REMARKS

AMENDMENTS TO THE DRAWINGS

Fig. 2A

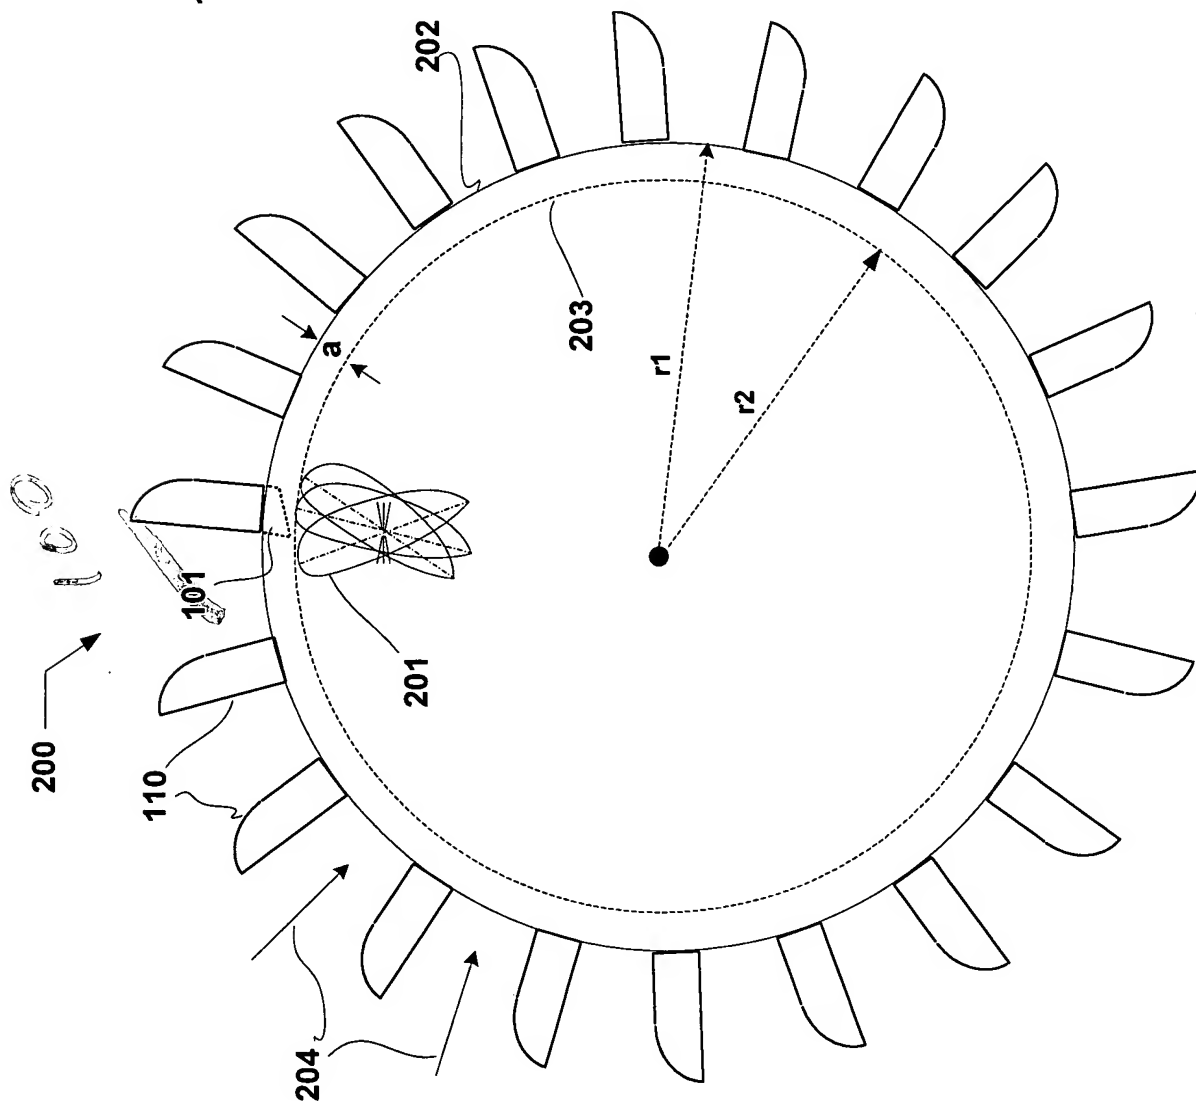
Amend Fig. 2A as shown to correctly label the extension as 100 vice 101.
